# Staff Report

## Historic Review of Exterior Alterations and Substitute Materials

HI-25-24

January 8, 2025

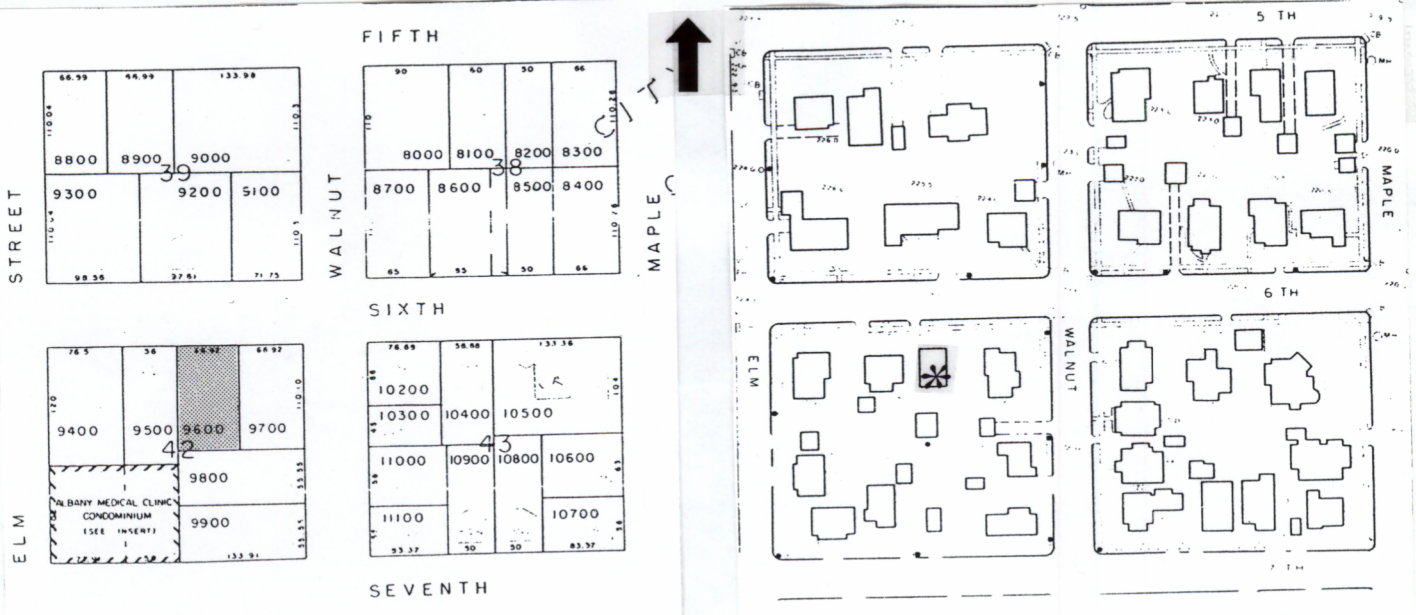
- 2.2 Historic Character (ADC 7.160(2)). The structure was constructed in the Queen Anne/Vernacular style. In 1997, the property owner expanded the porch and added additional detail work such as additional porch columns, decorative banister, and turret-style roof at the mid-line. The applicant is proposing to slightly modify the existing porch columns at this time due to deterioration. The porch columns are proposed to have round Tuscan style bases and caps (Attachment C.6). The style is very similar to what currently exists and appears to closely match the two original porch columns seen in the original photo (Attachment B.2). Based on these facts, criterion ADC 7.160(2) is met.

General Contractor TnT Builders Inc 620 Queen Ave. SW Albany, OR 97322 CCB #105770	Project Title Klaus Porch Modification 910 6th Ave SW Albany, OR 97321	Project Manager Brent Mosser	Drawing Title Elevation View
			Date November 7, 2024	Scale (not to scale)
			Phone (541) 926-3117

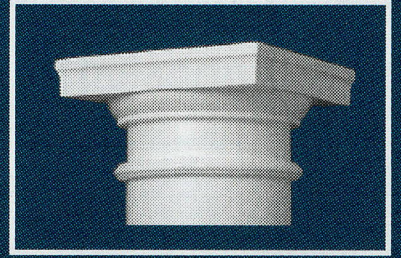
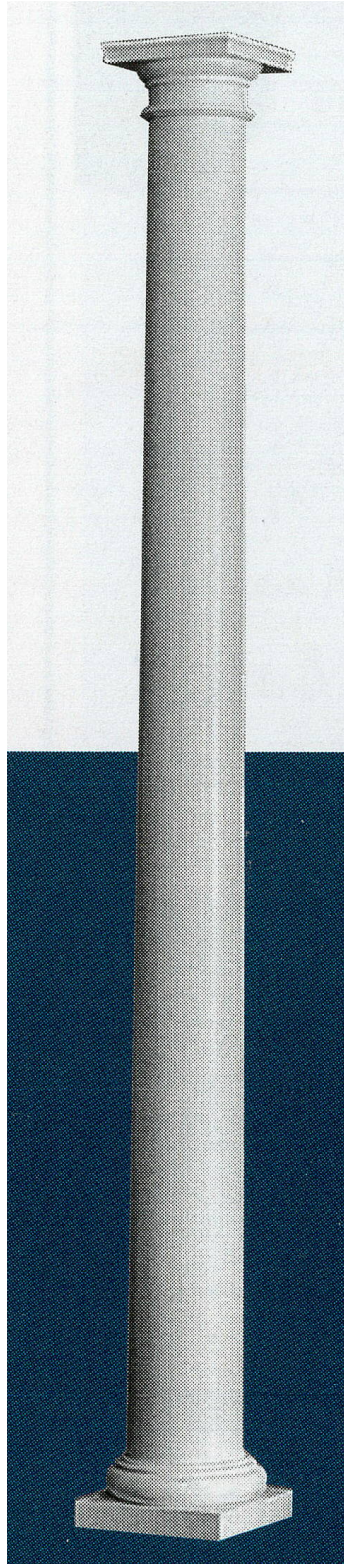
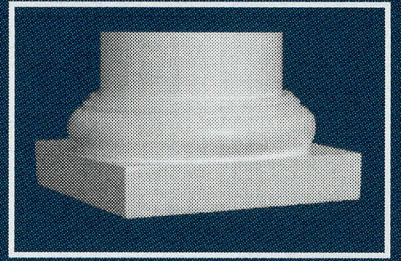
- 2.5 Deteriorated Features (ADC 7.160(6)). The applicant proposes to replace seven of the existing columns on the structure with fiberglass columns in a similar Tuscan profile. The applicant states that they are unable to find an exact match for the existing columns and proposes to use a close match. The Commission may determine if this criterion is met based on further evidence and testimony submitted.

- 1.1 The applicant provided a rendering of the proposed column in the application submittals. The proposed column appears to replicate the profile and size of the original column, with only minor detail changes. The Commission has the discretion to determine if this proposed column generally approximates the appearance of the previous column.
